January 23, 2026

Re: Two 3,000-gallon tanks, cartridge filtration, softener & GAC – [PR #101-2018](#)
Gran Moraine Winery – [PWS # 95573](#)
Final Approval

Plan review documentation was brought into OHA-Drinking Water Services on August 3, 2018, for the Gran Moraine Winery. The submittal was assigned plan review #101-2018 and included two 3,000 gallon buried concrete storage tanks (filled with hauled water purchased from various municipal water providers). The review also included verifying NSF certification for the pressure tank and secondary treatment consisting of a UV system, charcoal filters, and water softener.

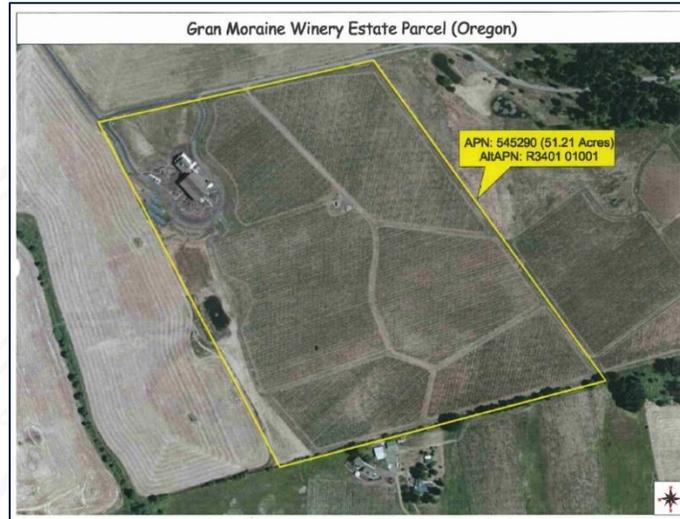
Viqua Pro24-186 (Part# 660086-R) UV units w/lamp part #602856 (**reviewed under PR#140-2020**). **Note:** UV light is 186-mJ/cm² thus a chlorine residual for the hauled surface water would not be required at distribution point. It is however required that when the hauled water is delivered that it does have a testable chlorine residual.
